**DATE:** June 20, 2013  
**TO:** Planning Commission  
**FROM:** Ben Lyman, Senior Planner   
Community Development Department  
**FILE NO.:** CSP2013 0011  
**PROPOSAL:** Brotherhood Bridge replacement and related improvements, including revisions to Industrial Blvd. Vintage Blvd., and trailhead parking lot intersections and separated path to Engineer's Cutoff.

## JNU: GLACIER HWY BROTHERHOOD BRIDGE REPLACEMENT

PROJECT No. NH-BR-0933(019) ~ 67987

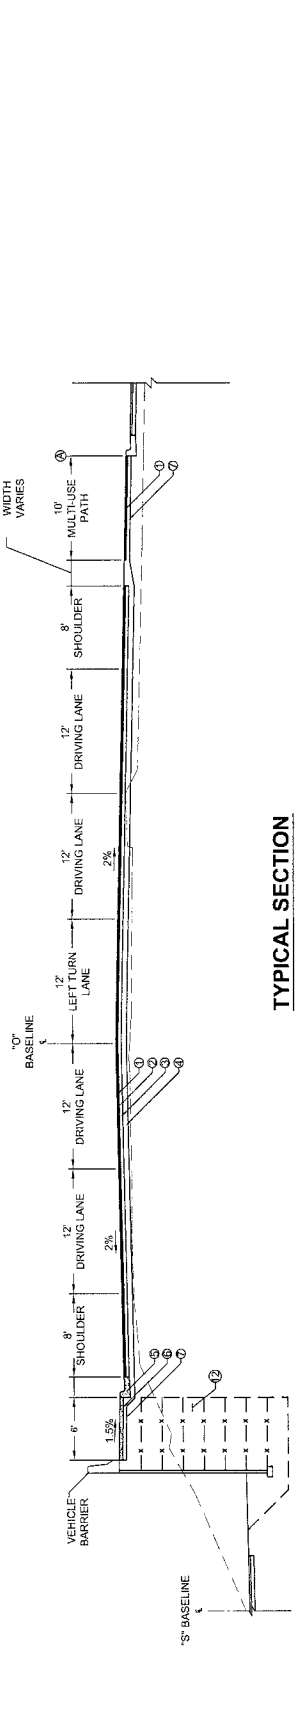
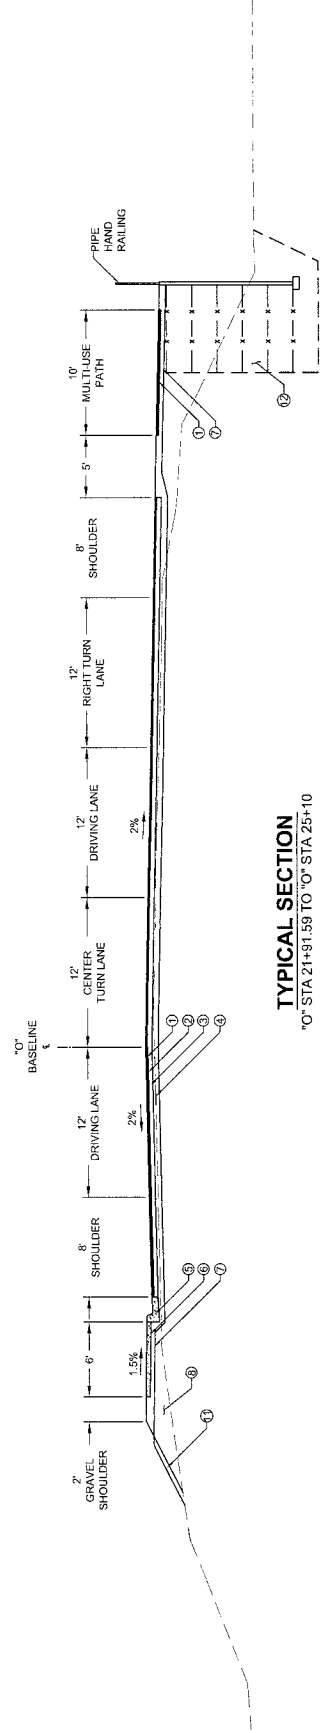
Intersections close to either end of the bridge (Vintage Boulevard to the east and Industrial Boulevard to the west) do not currently meet geometric design standards set by the American Association of State Highway and Transportation Officials (AASHTO). In order to provide adequate acceleration and turning lane lengths for these intersections, the DOT&PF proposes to widen the bridge substantially. Additional width is required to provide the proposed eight-foot-wide bicycle lanes on both sides of the bridge, a single six-foot-wide sidewalk on the south side of the bridge, and a 14-foot-wide separated multi-use path on the north side of the bridge, resulting in a 99-foot six-inch-wide bridge. (See Attachment A, Sheet B-2)
